APPEAL SUMMARY

Building/Business Name: Sandy.51

APPEAL DECISION**Alternate 2 hour beam assemblies with engineering analysis: Granted as proposed.**

Engineering Judgement Letter

Figure 1a: Beam Locations (4th Floor)

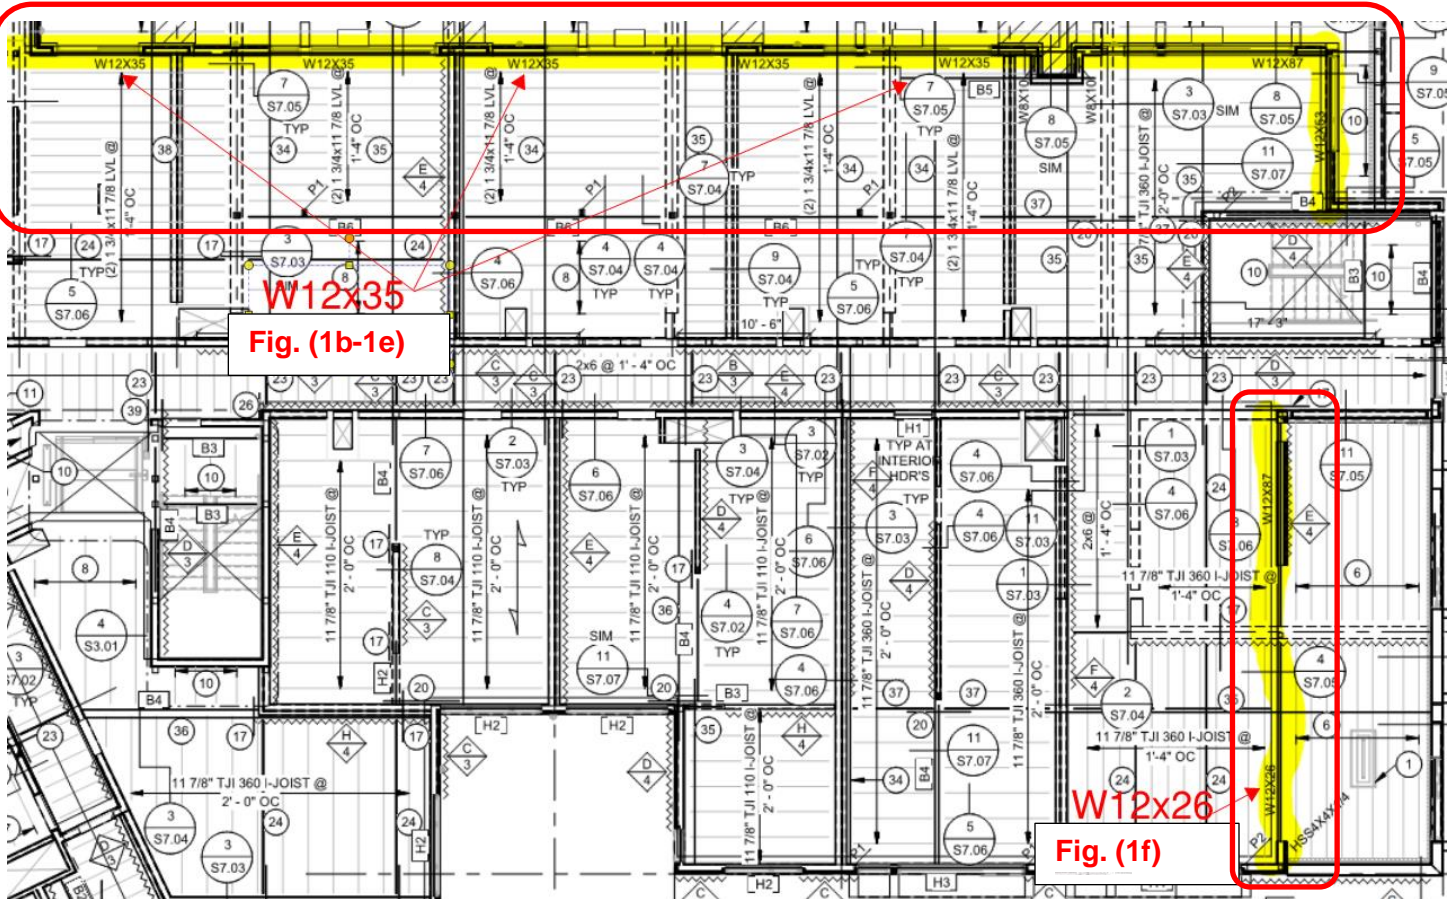
These beam assemblies supporting the exterior walls above (highlighted in Figure 1a) are required to be 2-hour fire-resistance rated per OSSC Table 601.

Figure 1b: Beam Protection (Condition B)

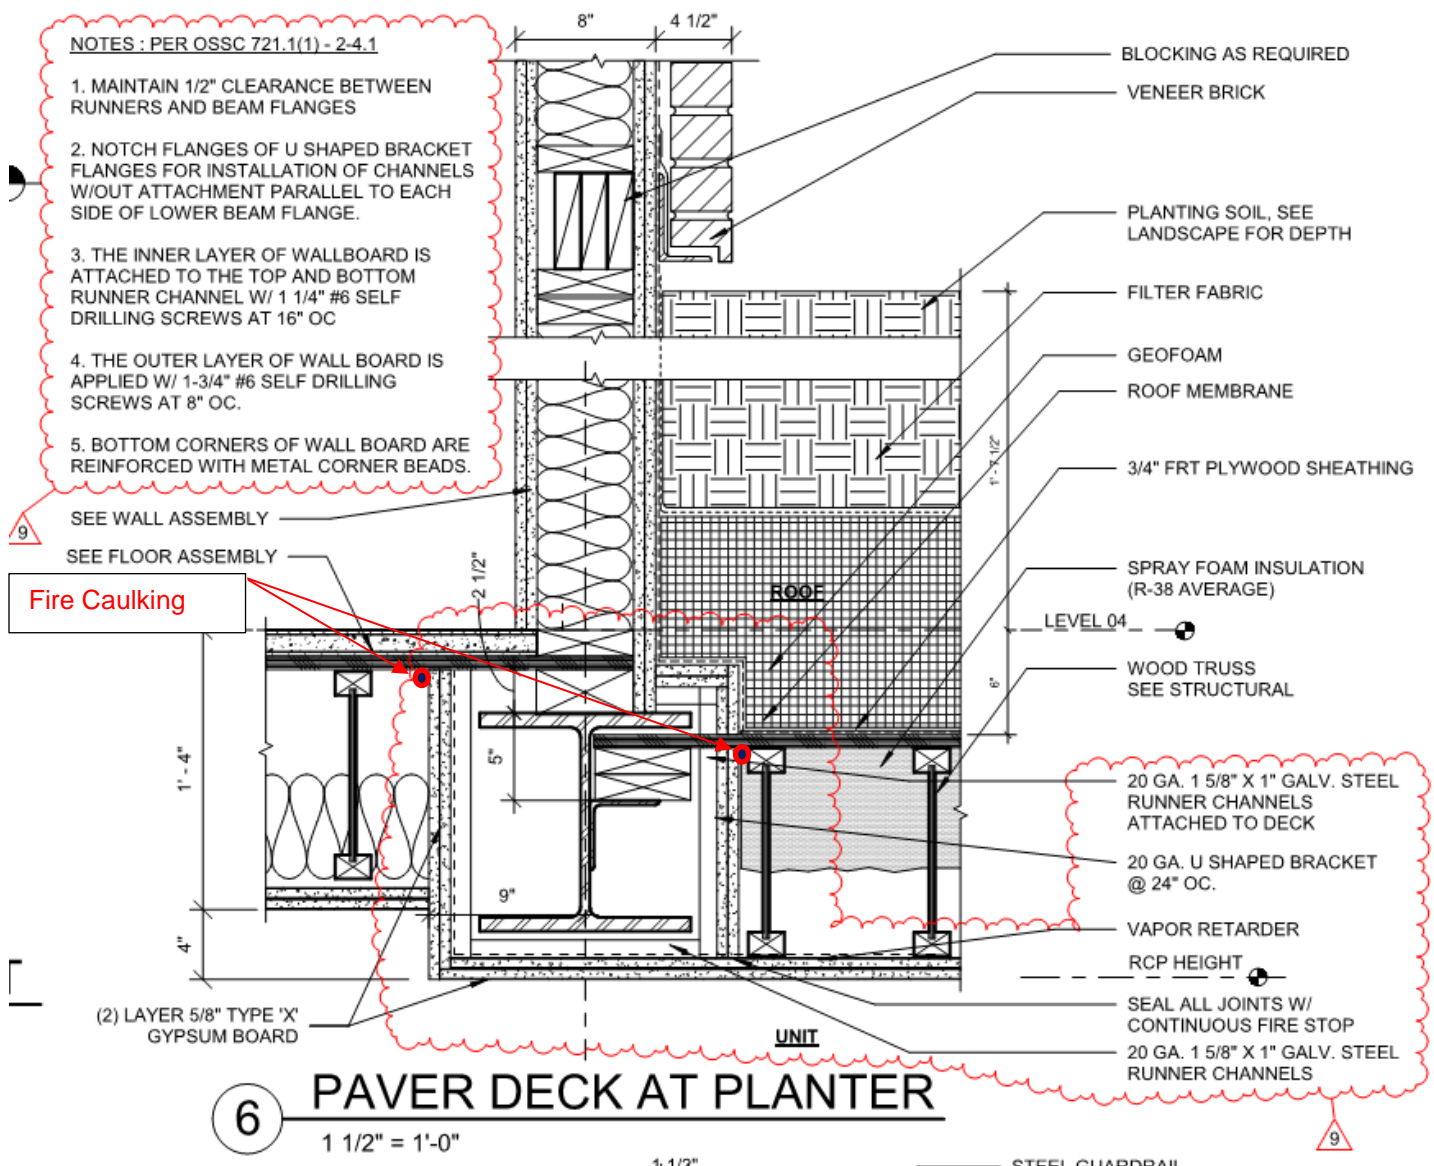
As shown on Figure 1 (b-e), beams (Minimum W12x35) are protected with gypsum wallboard (GWB) only. Figure 1f adds Mineral Wool to extend the fire rating of Beam W12x26.

Figure 1f: Beam Protection (Condition F (W12-26 Only))
(Detail for Table Below)

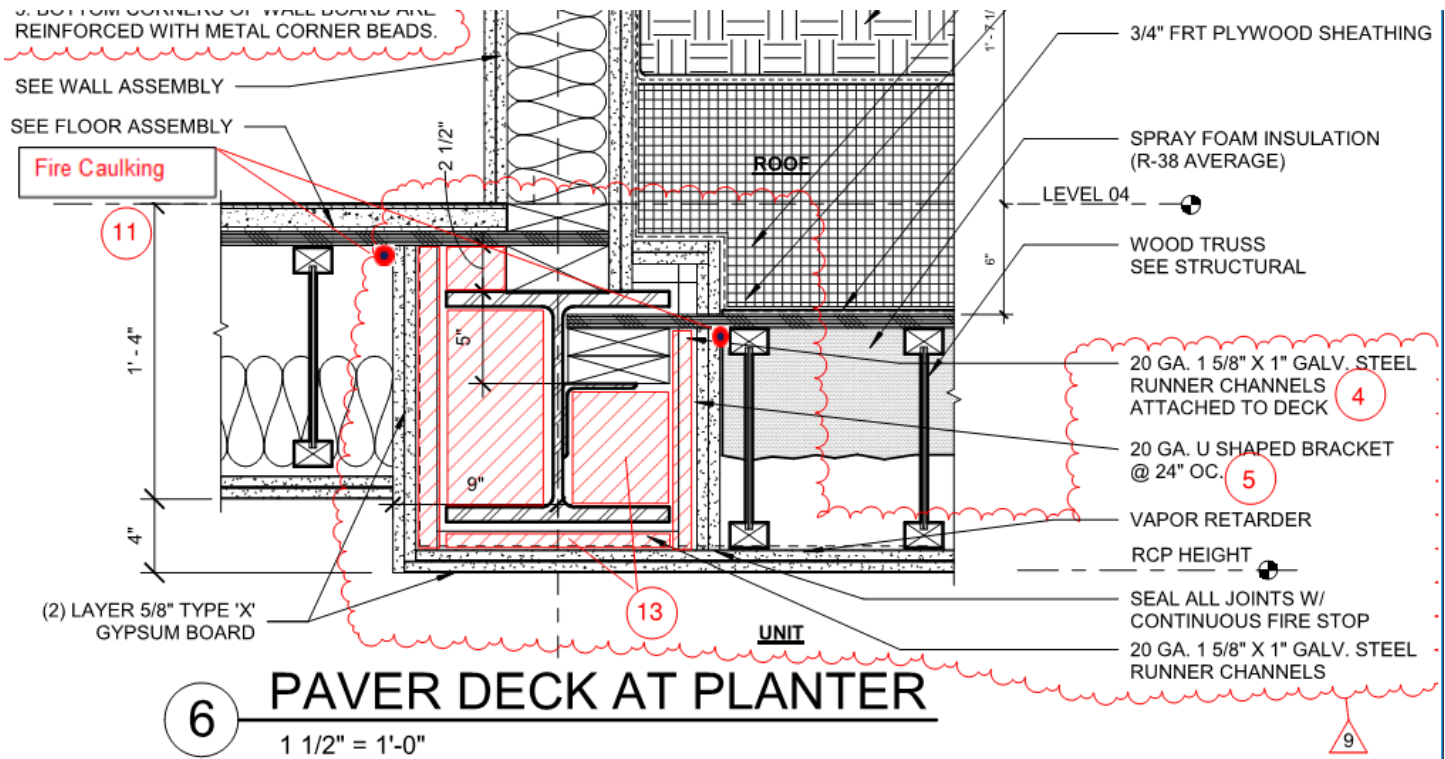
For this beam only, mineral wool will be added to the assembly to isolate the beam from external heating and extend the fire rating to meet OSSC minimum requirement. The joint between the vertical GWB and the plywood sheathing will be protected with a ¼" bead of fire caulking to ensure the joint will not be compromised during a fire condition.

Elements	UL Assembly N501(Fig. 2)	Proposed Assembly (Figure 1f)
Steel Beam	W8x24 (W/D = 0.70)	The proposed design uses a W12x26 beam . (W/D = 0.61) Less than tested beam W/D ratio.

13. Additional Protection	Not Provided	Mineral Wool insulation to be added fill gap around beam. (W12x35 Beam Only-Fig. 1f)
Fire Resistance	2-Hour	2-Hour (minimum)
